**HE File: MUP 16-005 (W)
S-16-003**

**DECLARATION OF COURTNEY A.
KAYLOR**

**SDCI Interpretation No. 16-001
(SDCI Project No. 3023843)**

This interpretation was requested by attorney David Bricklin on behalf of Michael McQuaid, et al., in conjunction with an appeal of a Master Use Permit decision, Project No. 3016702, relating to a proposed 40-story mixed-use development at 1613 Second Avenue. The interpretation request raises two issues: whether the ramps within the parking garage exceed the slope allowed under Seattle Municipal Code (SMC) Section 23.54.030 without meeting the criteria for variation from the slope standard, and whether SMC 23.54.040 “preclude[s] the current building design by failing to provide adequate space, access and pickup facilities for waste and recycling receptacles in the alley.” We understand this question to relate specifically to the placement and pick-up of waste materials in the alley, and have not included a detailed analysis of how other standards in Section 23.54.040 apply to this project. That said, activities in rights-of-way, including alleys, are largely regulated by the Seattle Department of Transportation according to the Street Use Code

Detail from Sheet T1.005, revised December 21, 2015

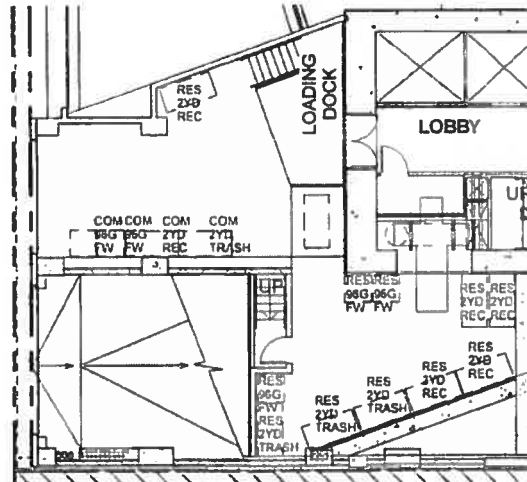
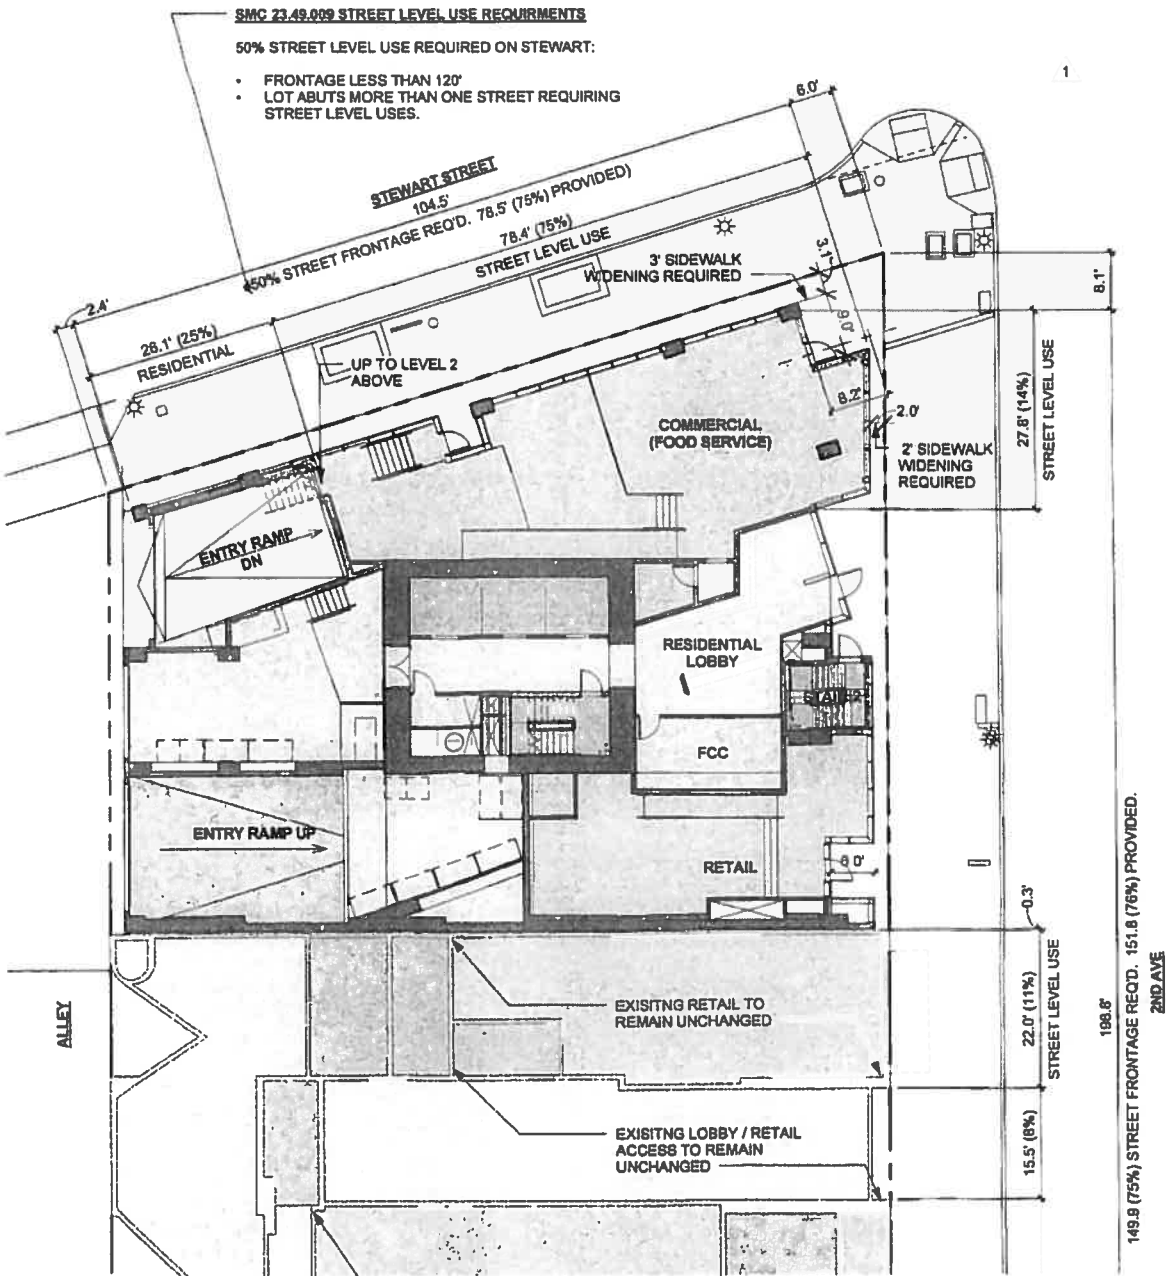
11. According to the plan on Sheet T1.001, all of the trash and recyclable storage containers would be two-cubic-yard containers, with the exception of food waste containers, which would be 64-gallon or 96-gallon containers. There are approximately 231 cubic inches in a gallon, so a 96-gallon container would contain 22,176 cubic inches. There are 46,656 cubic inches in a cubic yard, so a 96-gallon container would contain about half of a cubic yard. The two-cubic-yard containers as depicted on the plans are approximately six feet wide.

12. The trash container diagram shows a total of four two-cubic-yard dumpsters for trash (three for residential uses and one for commercial uses). A total of six two-cubic-yard dumpsters are proposed for recycling (five for residential uses and one for commercial uses). Five 96-gallon food-waste containers are proposed, three for the residential units and two for the commercial uses.

4. No more than two of the two-cubic-yard dumpsters would fit, in one row, across the 13-foot-wide area in front of the alley entrance to the trash storage area. A total of four dumpsters for trash are proposed, and another six for recycling. Even if trash and recycling pick-up were scheduled for different times, the recycling dumpsters would have to be placed three-deep in order to fit within the available 13-foot frontage. It is clear that placement of the dumpsters in the alley for pick-up would be impractical, as the appellants have suggested.

5. However, based on the communication from Seattle Public Utilities, the large dumpsters will not be stored in the alley, but rather will be staged for pick-up in the area immediately within the building, at times agreed-upon by that department and building representatives. The only waste containers that would be placed in the alley would be the five food-waste containers. These are 2.5 feet wide, so all five of them would fit across the available 13-foot entry.

6. SMC 23.54.040 includes standards governing minimum area for solid waste container storage, and access to the storage location. (It also provides that alternative measures may be approved, in consultation with Seattle Public Utilities under circumstances described in subsection 23.54.040.I.) A complete analysis of how those standards apply to the proposed trash storage room is beyond the scope of this interpretation, as the question raised was limited to the adequacy of the space, access and pick-up facilities in the alley. The provisions relating to pick-up activity in the alley are very limited. Under Section 23.54.040.F, collection locations may not be within a bus stop or within the right-of-way abutting a vehicular lane designated as a sole travel lane for a bus. A 21-foot overhead clearance is required for the collection vehicle. Under Section 23.54.040.G, direct access must be provided from the alley or street to the containers, and the pick-up location is required to minimize any blockage of pedestrian movement along the sidewalk or other right-of-way. If the pick-up location is on the planting strip, any required landscaping must be designed to accommodate the containers. The proposed pick-up location, based on the agreement between the project architect and the SPU representative, meets these standards: The collection location is within the trash storage area, immediately adjacent to and

directly accessible from the alley. It is not on a planting strip, within a bus stop or abutting a right-of-way solely designated for buses. No overhead projections are proposed in the alley, within the required 21-foot clearance. The larger dumpsters will not impede pedestrian movement along the alley, as they will not be stored in the alley. The food waste containers may be placed in the alley when pick-up is scheduled, but based on their size and number they would not impede pedestrian passage.

Detail from Sheet A1.106

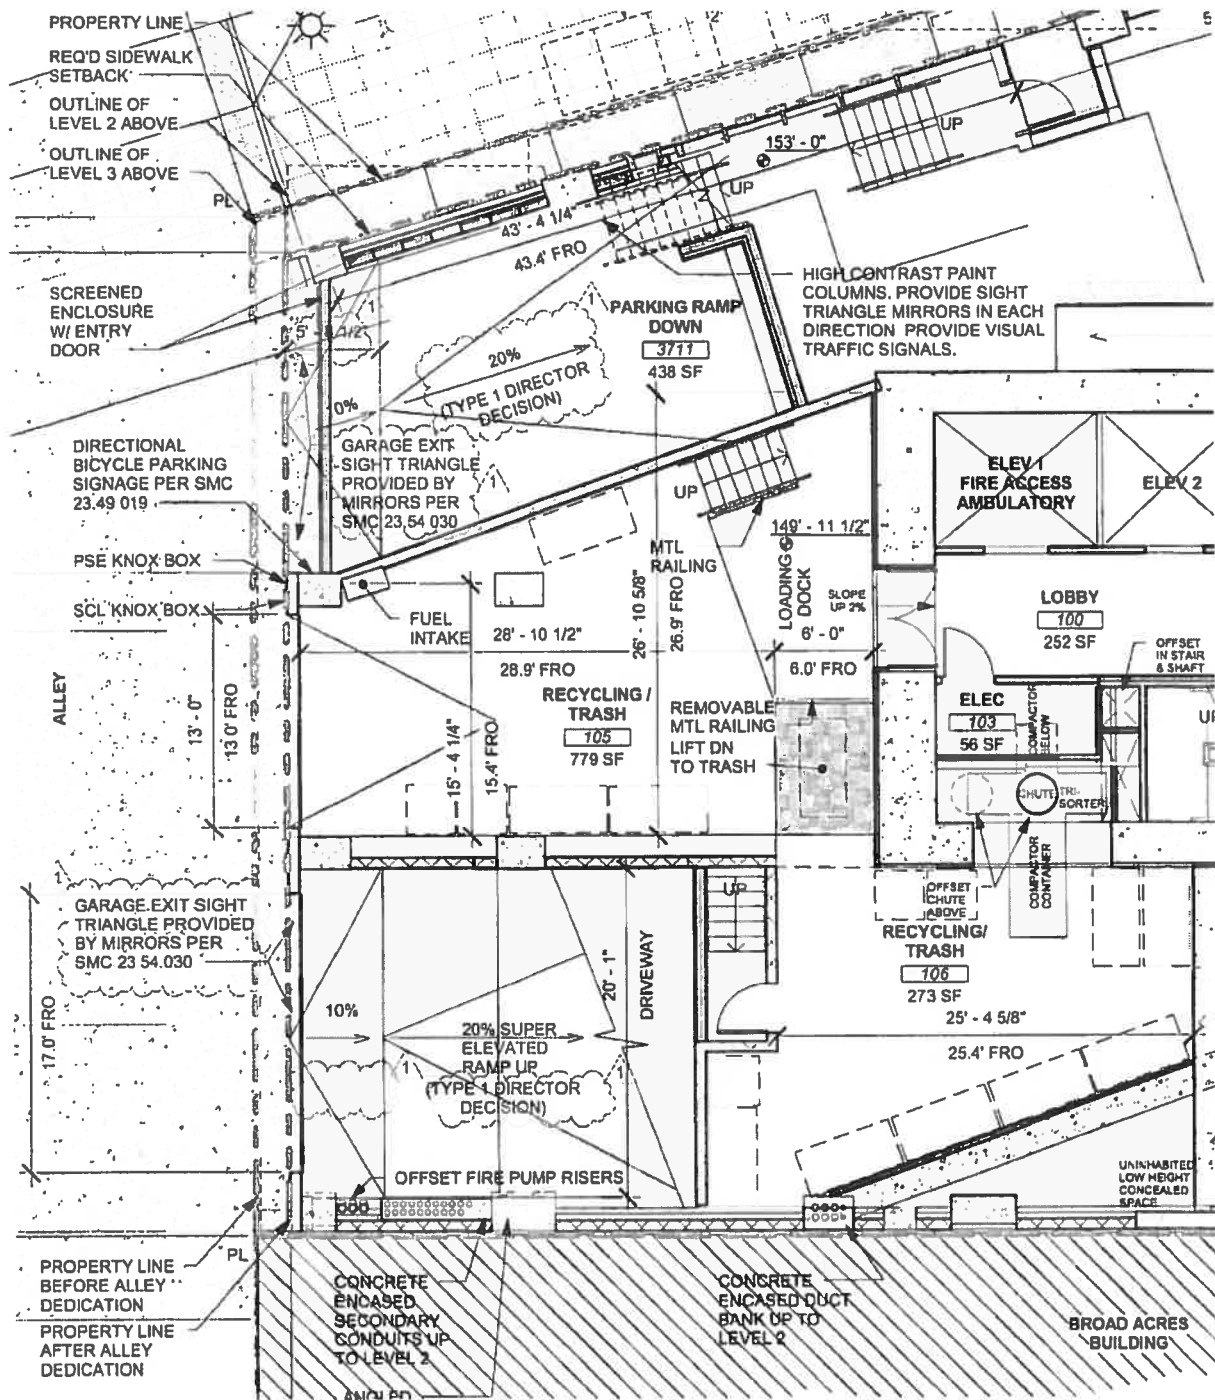
8. In a correction sheet dated November 6, 2015, Bradley Wilburn, the DPD zoning reviewer, asked the applicant to explain why the project qualifies for aisle slope in excess of 17 percent under

the criteria of subsections 23.54.030.D.3.a through 23.54.030.D.3.c. Sean Ludviksen of the Hewitt firm responded:

The site access (alley) cross slopes of approximately 7.6% at the north driveway and approximately 10% at the south driveway make 15% driveway slopes infeasible and no slopes are steeper than necessary to accommodate lot conditions. The driveway usability is achieved via crest and sag blends shown on A1.106. Aisle safety throughout is enhanced via mirror placement and high contrast painted marking locations outlined in association with DRB Departure #1.

1. Passageways for cars within the building are properly regulated as aisles, rather than driveways, so they are generally subject to a slope limit of 17 percent rather than 15 percent. The allowance of a 20 percent slope in place is a modest deviation from the 17 percent standard.

The relatively small lot size and the unusual shape of the lot are both “special characteristics” of the lot that create unusual constraints for a parking garage. Providing greater slopes right off the alley helps to minimize how much of the ground level is used for parking access, freeing more area for desirable ground-level uses. Features such as mirrors are proposed, to help to ensure aisle safety.

2. Because the site is tight, there is minimal circulation space on each level, and a fair amount of slope is needed in order to obtain reasonable ceiling height on each level. The floor-to-floor heights on most of the parking levels is 8’8”, which allows a modest ceiling height once floor construction is subtracted. The applicant reasonably concentrated the slope in areas that would not be used for backing out of parking spaces.

3. There is a reasonable basis for concluding that ramp slopes steeper than 17 percent in places is necessary for a garage on this site, due to the small size of the site. The additional amount of slope is modest, and appears to be the minimum necessary in order to achieve a reasonable ceiling height on each level, and minimize slope in areas where cars will be backing out of spaces. We see no basis for concluding that this modest increase in slope in limited areas would cause the garage not to be usable.
